RE: DRAINAGE PLAN FOR LOT 99, SANDIA HEIGHTS SOUTH
(C-23/D28) ENGINEER'S STAMP DATED JUNE 22, 1992

Re: Additional Drainage Improvements Relating to Construction on Lot 99, Sandia Heights South (C23/D27)

**DRAINAGE/GRADING PLAN
FOR
LOT 99
SANDIA HEIGHTS SOUTH**

ALTERNATE # 1

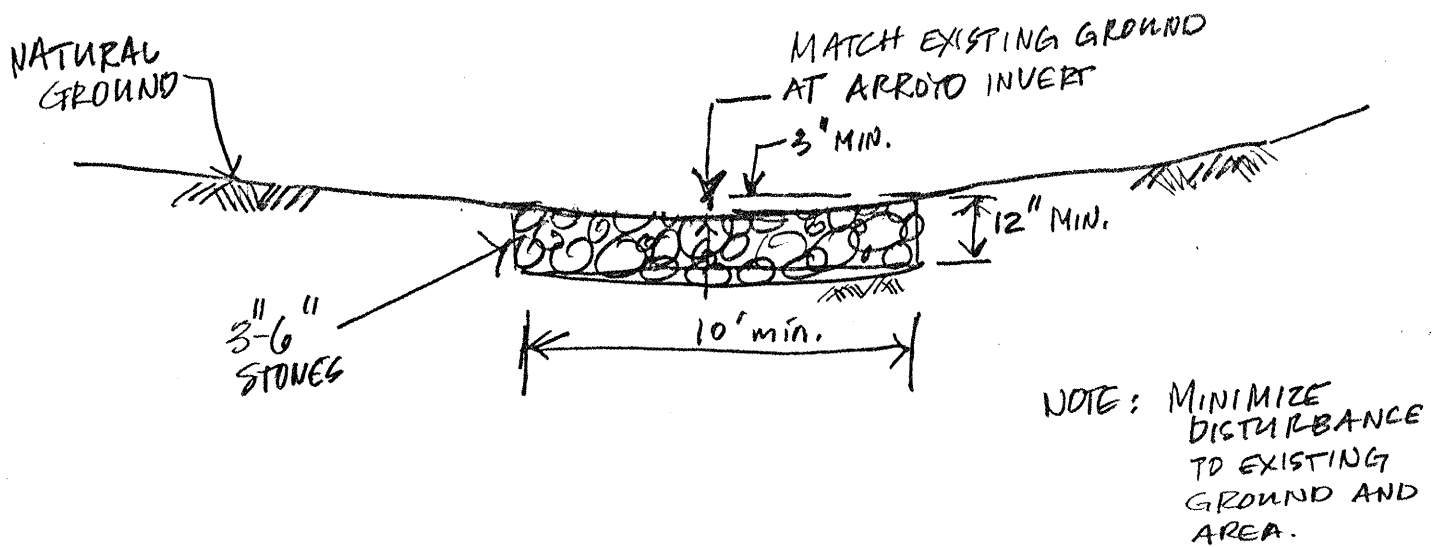
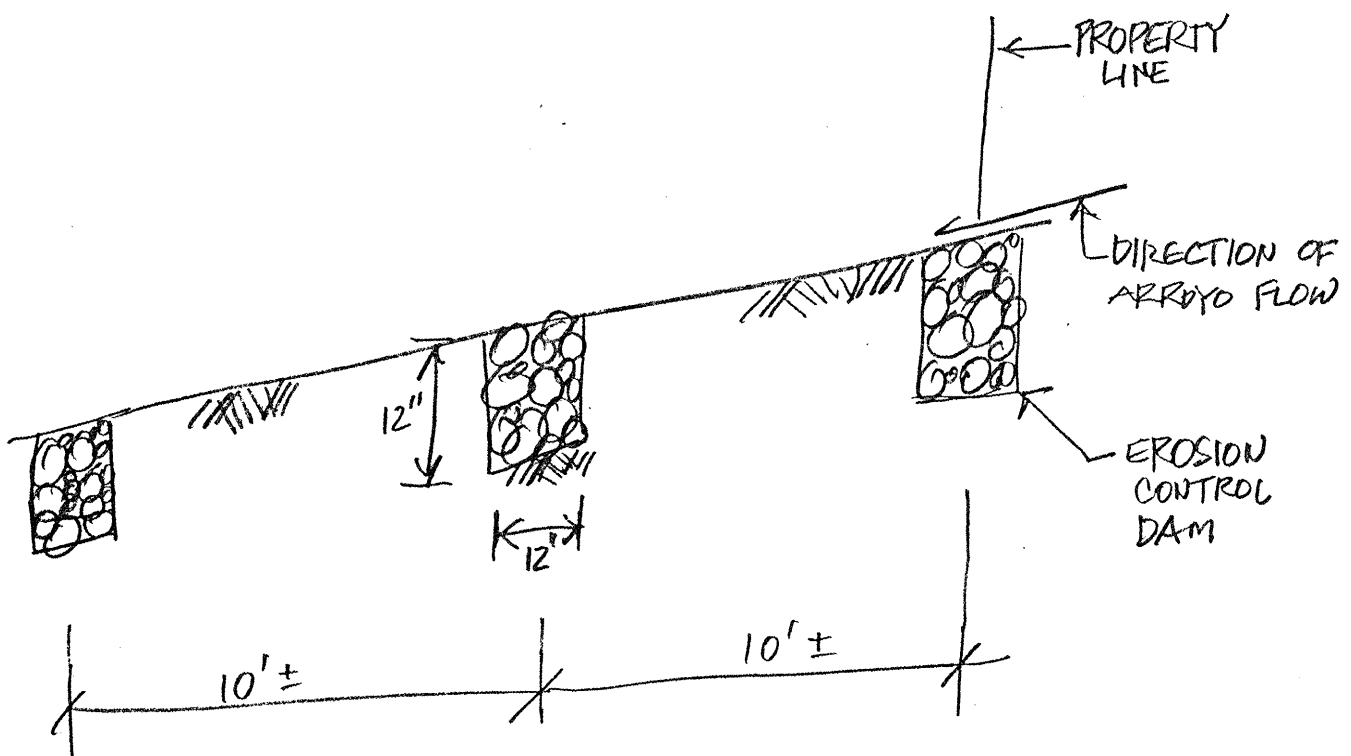
The purpose of this letter is to present two alternatives for additional drainage improvements to mitigate erosion process as a result of construction on Lot 99, Sandia Heights South; your neighboring lot to the east. Two alternatives are provided in the enclosed sketches. These alternatives are those discussed with you during our field visit on Friday, June 26, 1992. The improvements are proposed to be located on your lot in order to achieve maximum effectiveness. The cost of constructing the improvements identified on the sketches will be borne by the owner of Lot 99 or the contractor.

Accordingly, please review the enclosed sketches of the proposed drainage improvement alternatives. If you have any questions, please contact me. I personally believe Alternate No. 1 may provide the most effective protection. If you approve of one of the alternatives, please indicate your approval by signing in the space provided below and indicate which alternative is acceptable to you. Please return the original of this letter to Mr. Gilbert Aldaz, City/County Floodplain Administrator, Hydrology Division, Public Works Department, City of Albuquerque, P.O. Box 1293, Albuquerque, NM 87103, telephone 768-2650. The copy is for your records.

DRAINAGE/GRADING PLAN

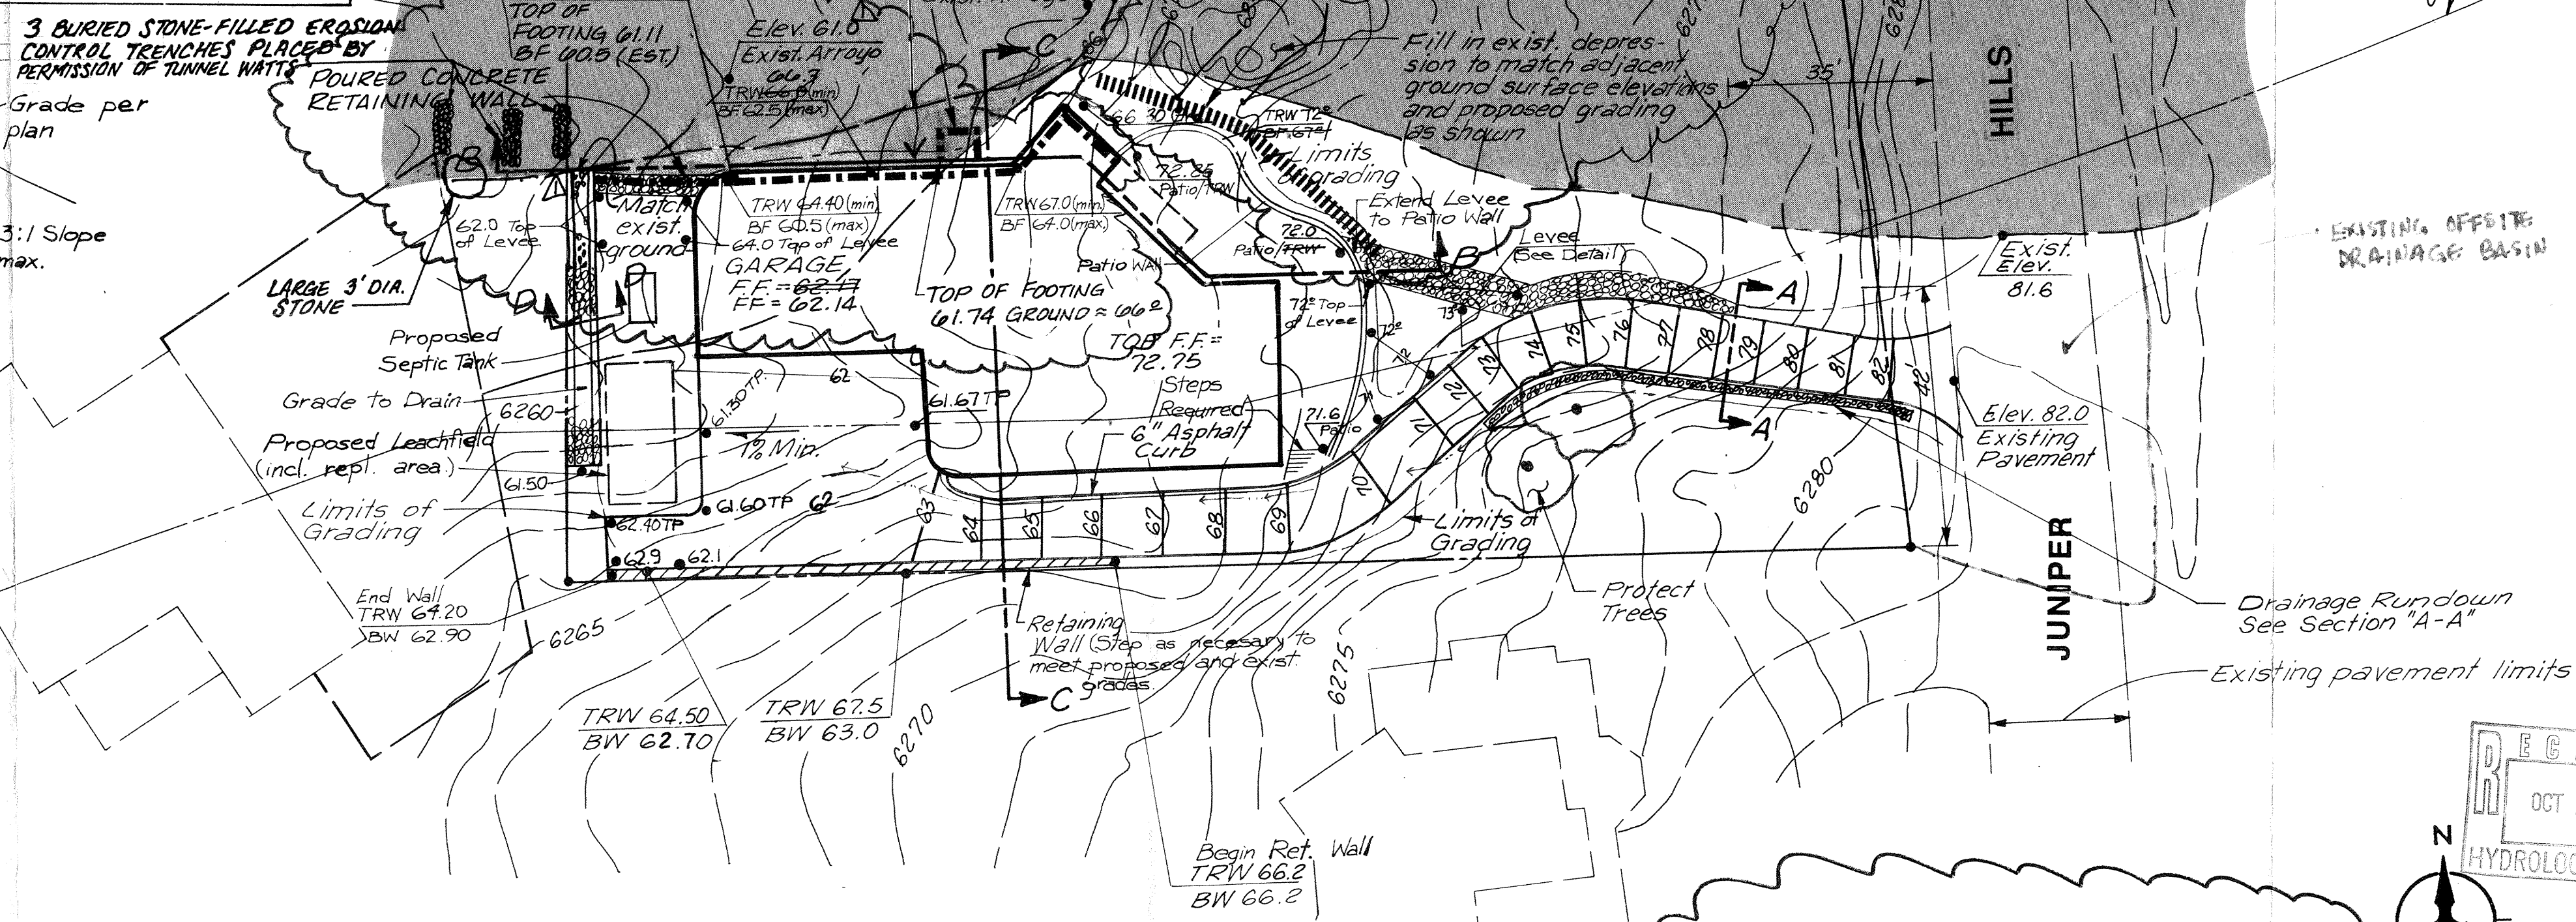
REVISION TO CERTIFICATION: 10-15-92 TO ADD EROSION CONTROL TRENCHES ON ADJACENT LOT
